CITY OF SAINT PAUL HERITAGE PRESERVATION COMMISSION STAFF REPORT

FILE NAME: 1065 Summit Avenue

APPLICANT: Shannon West, Willin Consultants Inc. for Sprint

HPC SITE/DISTRICT: Hill Historic Heritage Preservation District

ENLARGED ROOF PLAN

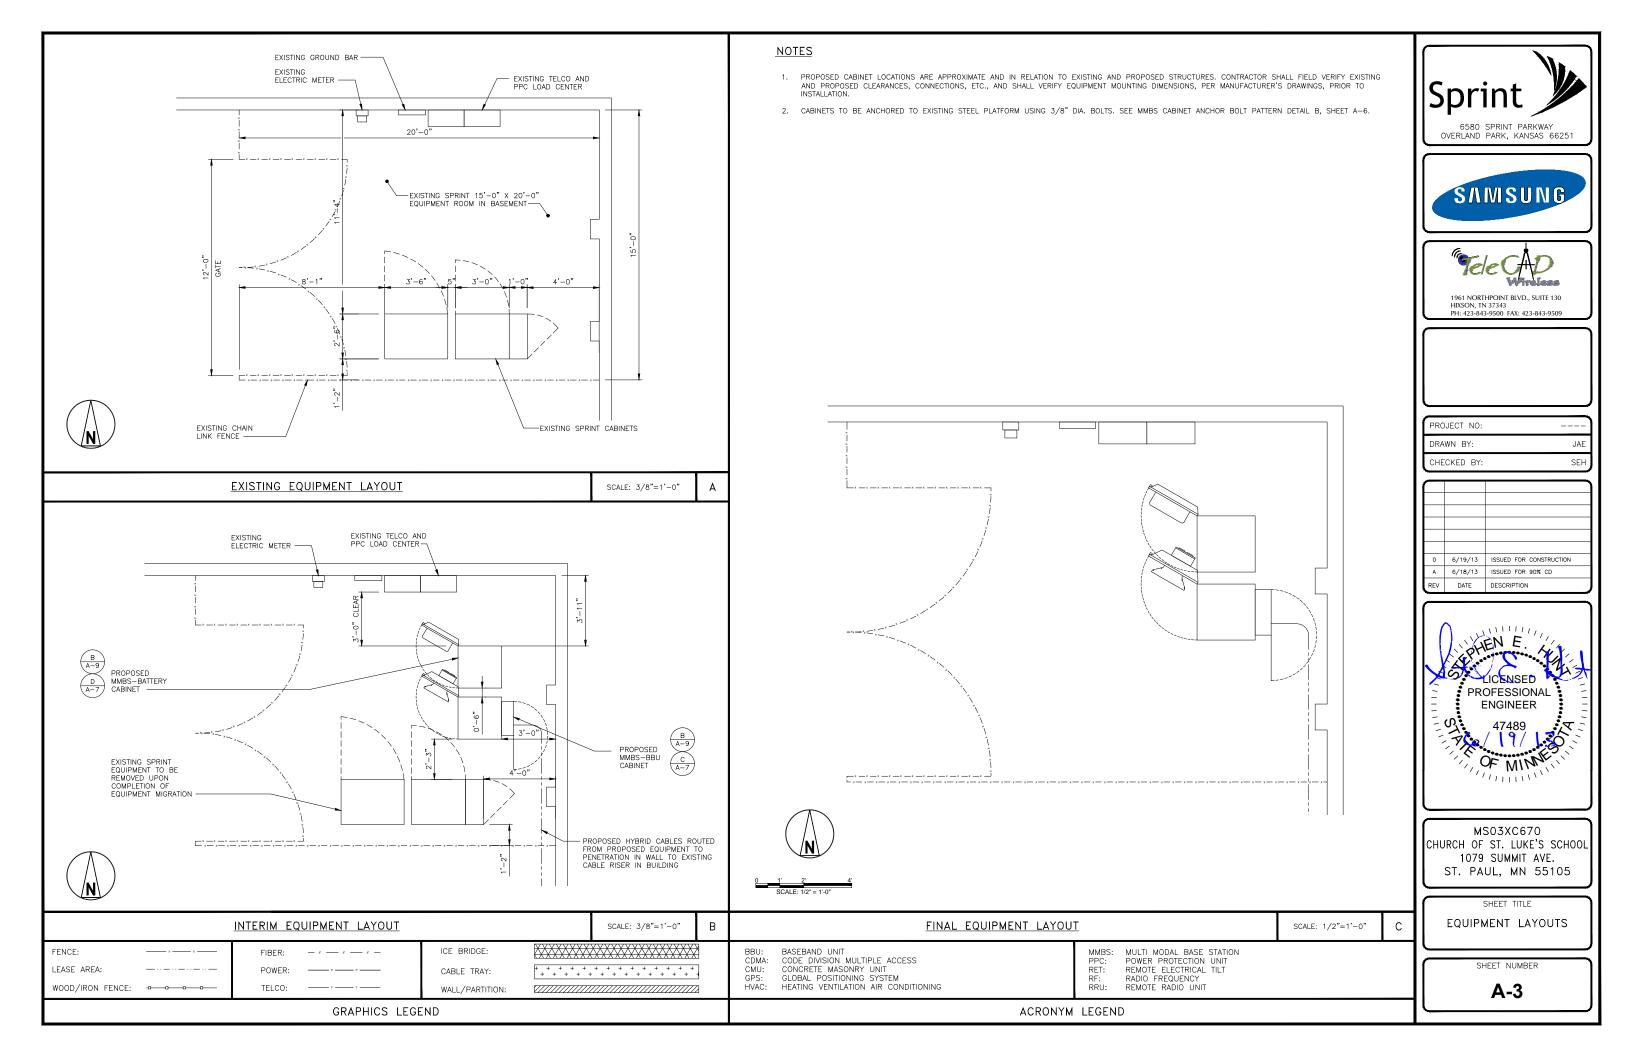
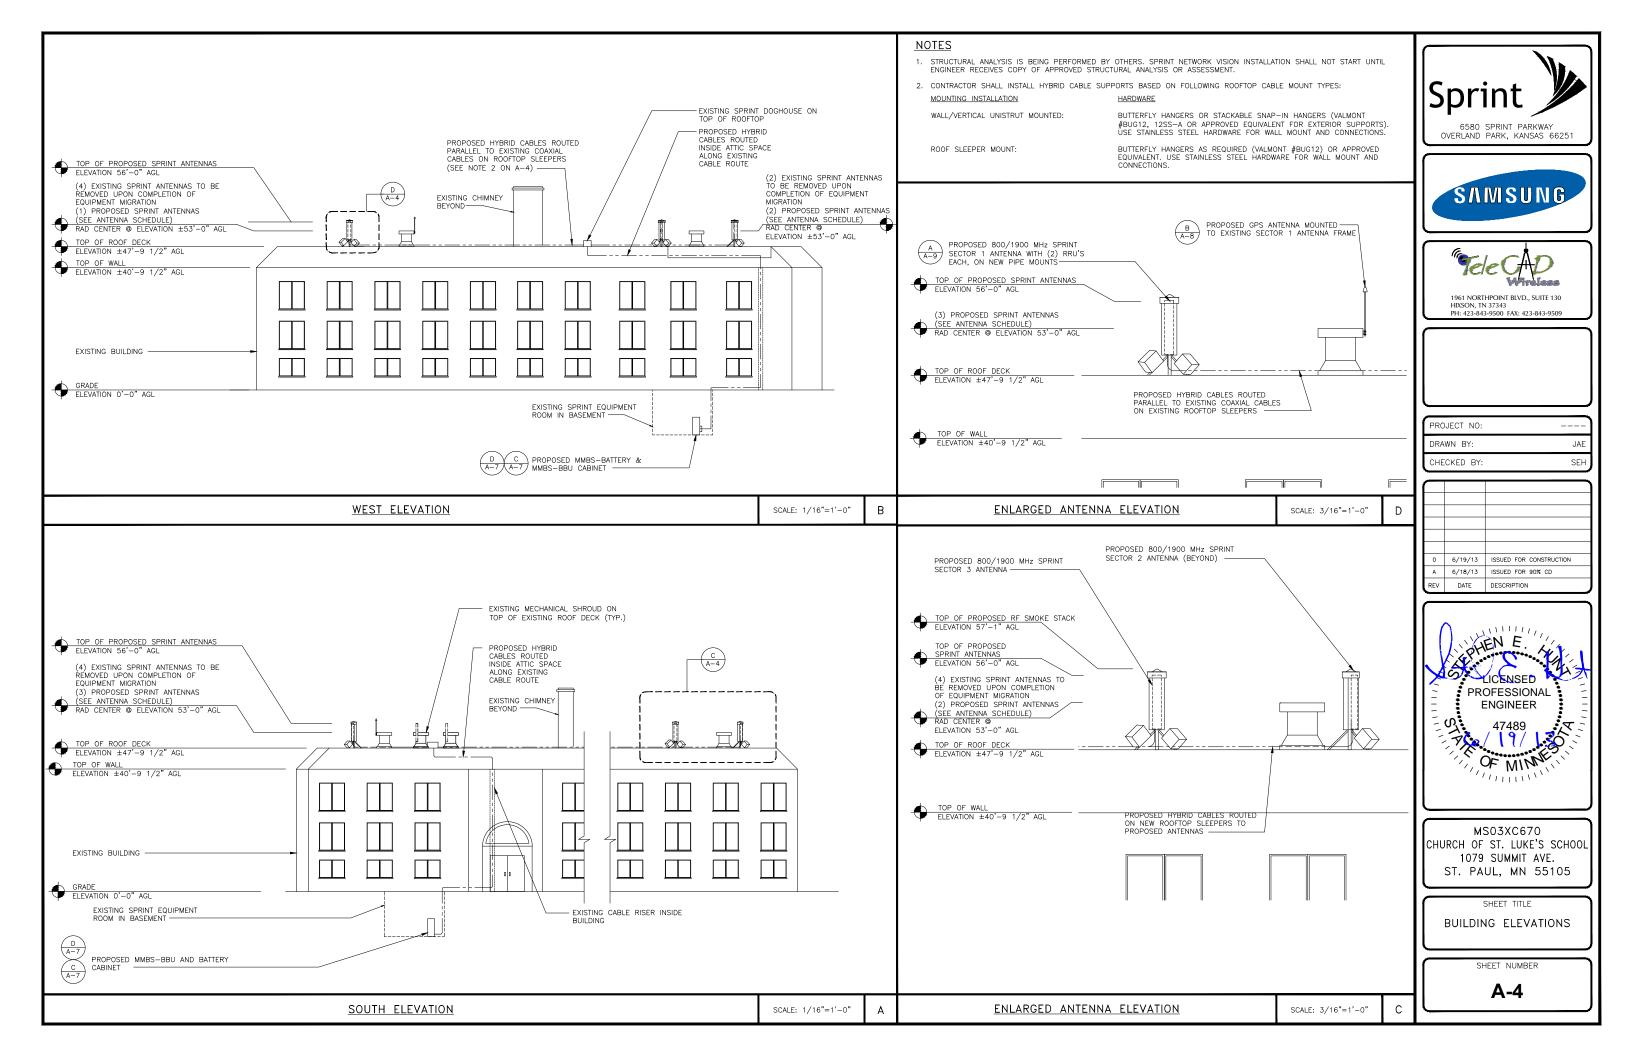
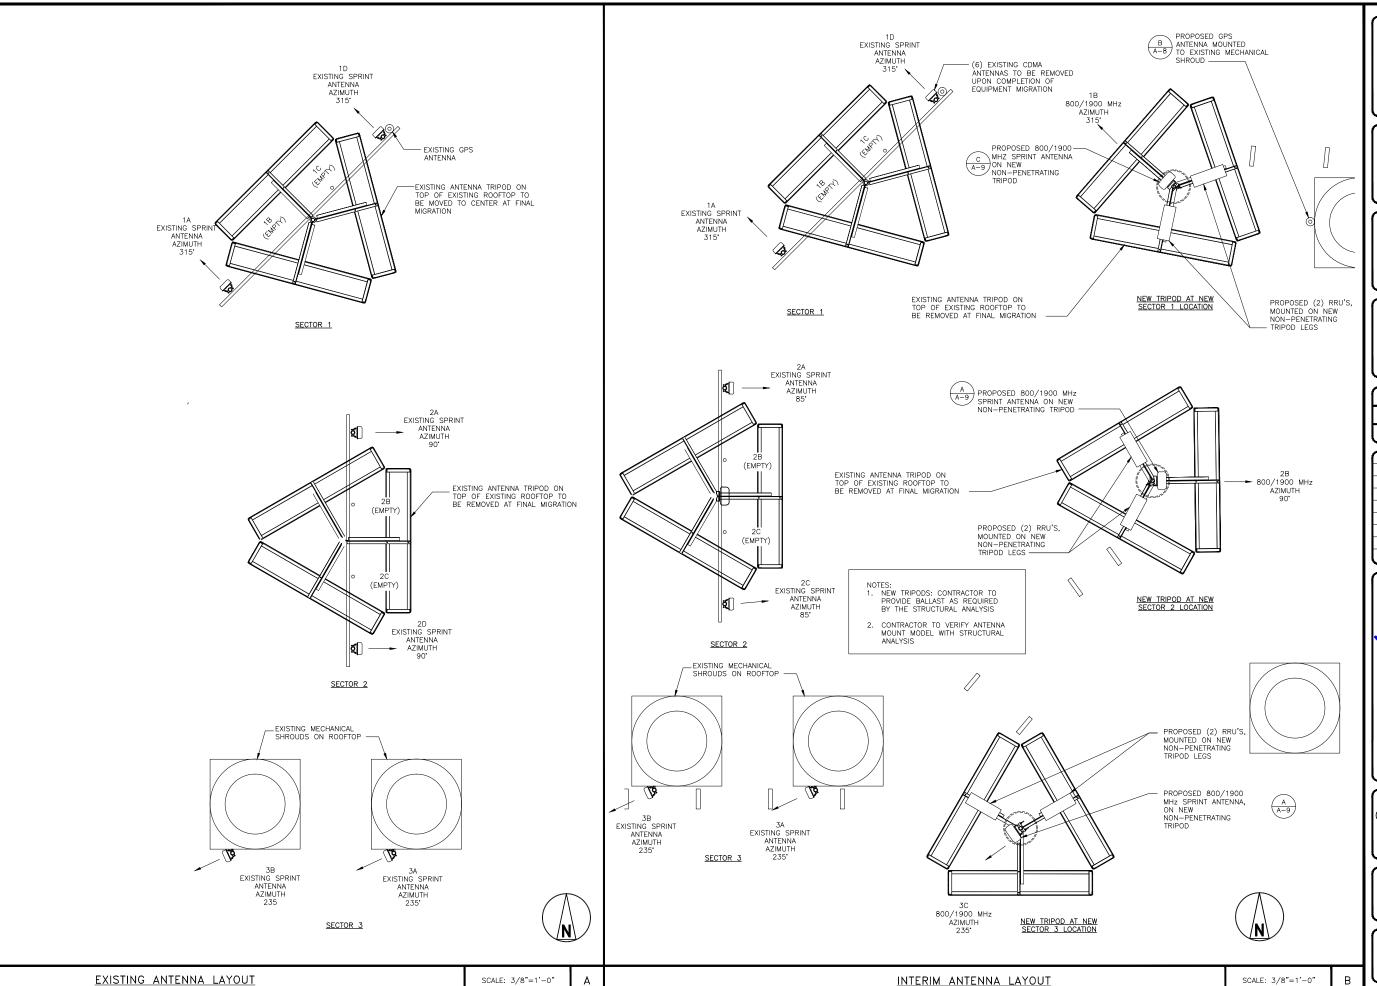
- 9. Sectors 2 and 3: Sec. 74.65.(g)(3) The building is 44 ft. tall and has a flat roof with a parapet that is approximately 2 ft. tall at the perimeter. The proposed stacks (Sector 2 & 3 antennas) are 9 feet 3.5 inches tall and placed closer to the two primary elevations with a 10 ft setback from the roof edge. This allows Sector 2 to be visible approximately 70 feet east from the base of the building and Sector 3 to be visible at approximately 70 feet south from the building. These points fall within the boulevards and yards along the north side of Summit Avenue and west side of Oxford Street. With the 10 foot setback, approximately 3.5 feet of the stacks will be visible from the curbs directly east and south of the property. These stacks are not inconspicuously sited. As proposed, the installation of the Sectors 2 and 3 antennas will have a negative visual impact on the building, site, and its environment. If setback an additional 10 feet, the visibility of the stacks from the right-of-way and immediately adjacent properties would be greatly reduced.

- 10. **Sectors 2 and 3:** The Hill District guidelines state, "roof hardware such as skylights, vents and metal pipe chimneys should not be placed on the front roof plane." **Sec. 74.65.(e)(1)c.** The intention of this guideline is to guide the placement of these types of features to non-primary and non-visible elevations of a roof. Moving Sectors 2 and 3 back from the parapets will meet the intent of this guideline.

- 1. The Sectors 2 and 3 antennas (stacks) shall be setback 20 feet from the southern and eastern roof edges so as to be minimally visible from the public right-of-way along Summit Avenue and Oxford Street.
- 2. The proposed stacks shall have a dark finish (such as bronze or black).
- 3. The building permit submitted for this work shall include removal of the existing rooftop antennas and associated rooftop equipment as well as a removal completion date.
- 4. Any revisions to the approved plans must be submitted to the HPC and/or staff for review.
- 5. The HPC stamped approved plans must be kept on site during the construction project.
